UNITED STATES PATENT AND TRADEMARK OFFICE

Office Action Summary

Application No.
09/126,826

DETAILED ACTION

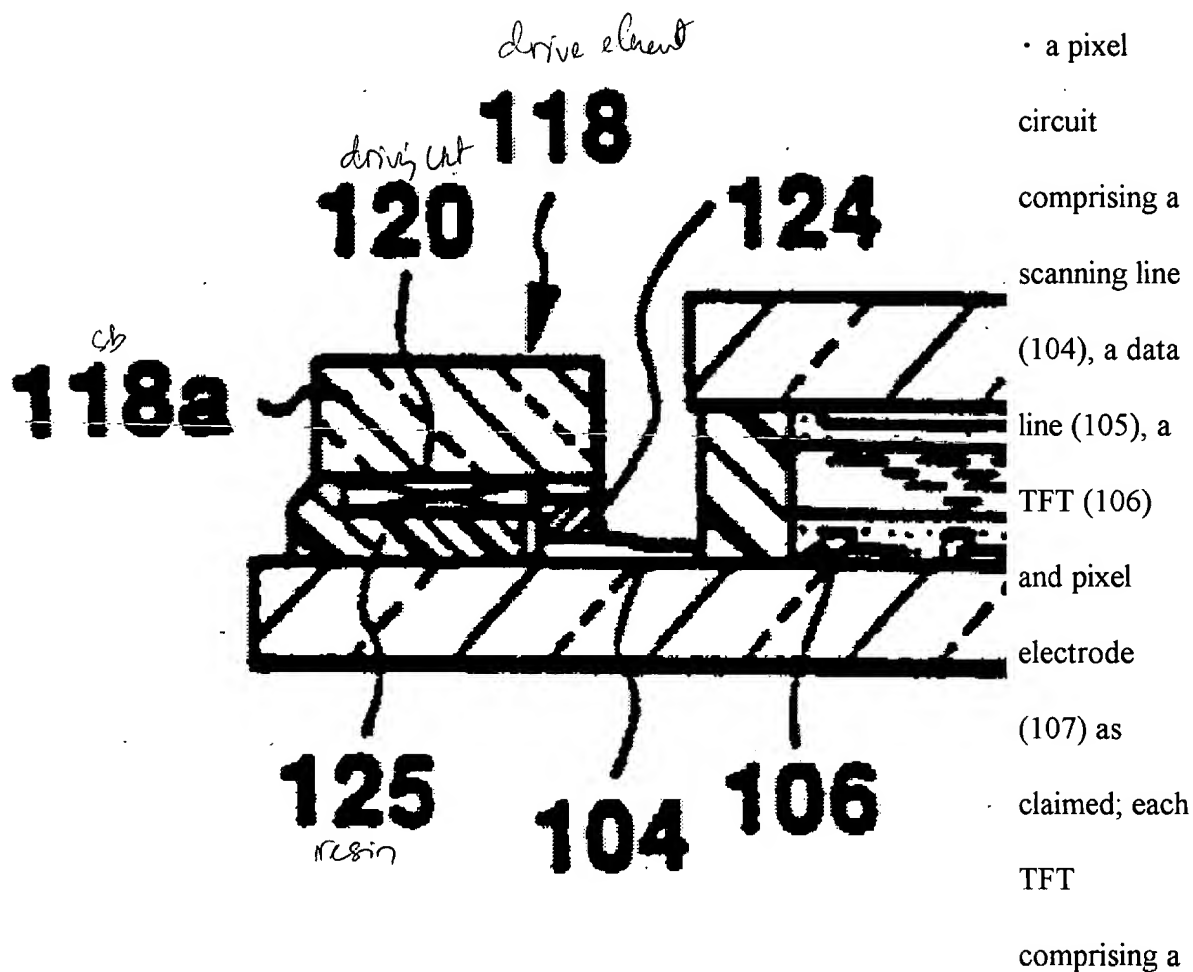
Regarding claims 72-73, 75-79, 81-83, 90-91, 93-96, 93-96 and 98-99, Mawatari et al. disclose an active matrix LCD device (figures 3-4) having:

- a pair of opposed substrate (101, 102);

channel region crystal silicon (semiconductor 110), a silicon oxide/polyimide passivation (gate insulating 109) (figure 6);

- a liquid crystal material (LC) disposed between the pair of opposed substrate;
- a resin (125) forming on the substrate (101);
- a base film (substrate 118a) in contact with the resin (see enlarged figure 4 reproduced above);

- a driver circuit (120) comprising thin film transistors (TFTs) formed on base film (118a);
- a passivation film inherently covered TFT having a contact hole for electrical connection through a tapered configuration (according to matrix LCD);

Although Mawatari et al. do not explicitly disclose that the driver TFT including a passivation film having a contact hole connected to the pixel TFT by a wiring, it would have been obvious to one skilled in the art to form a driver TFT having a passivation layer and a wiring to connect the pixel TFT from the driver TFT as shown by Yamazaki et al figure 4C in order to drive the pixel TFT in an LCD device.

Regarding claims 44, 72, 78, 90 and 95, Applicants contend that both Mawatari et al. and Yamazaki et al. fail to teach a resin formed on the substrate and a base film in contact with the resin as claimed (amendment, page 9). The Examiner is not convinced by this argument since the same is true of the Mawatari et al. driver circuit as noted above (see paragraph 4).
